Amendments to the Drawings:

U.S. Appl. No.: 10/577,398 Inventor(s): Koichi TAKEDA ANNOTATED SHEET

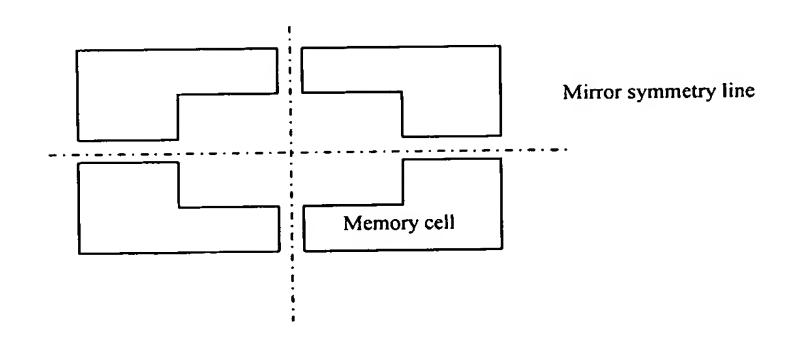
Claim 43 has also been mended to address the issue raised in the Office Action. For the conveniences of the Examiner, applicants point out that this layout is explicitly illustrated in Fig. 30 and is also specified by the following drawing.

FIG. 1

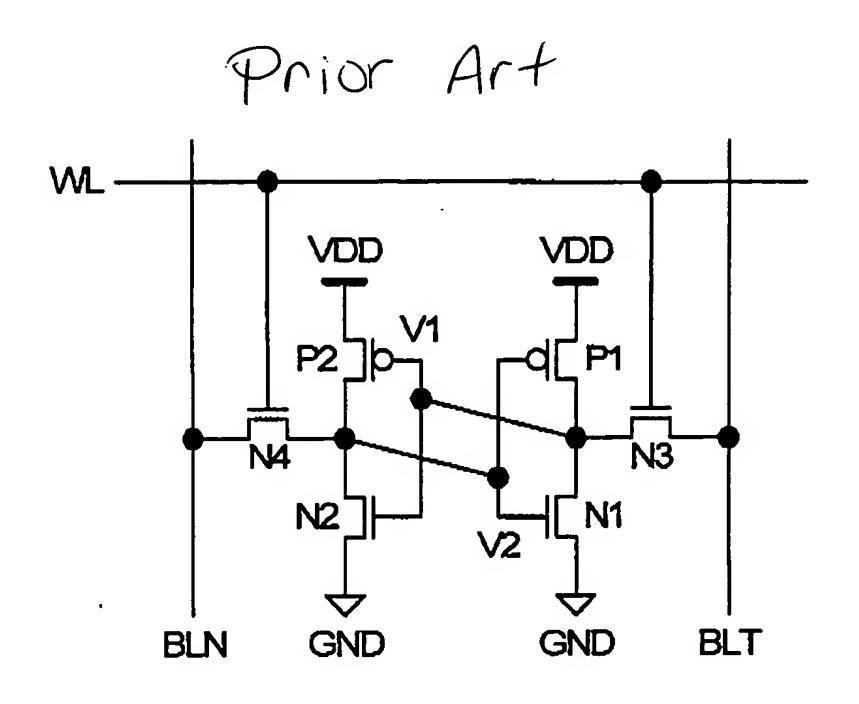
The drawing figures 1-6 have been amended by adding a legend, "Prior Art," as requested by the Examiner. Appended to this amendment is an annotated copy of the previous drawing sheets which have been marked to show changes presented in the replacement sheet of the drawing.
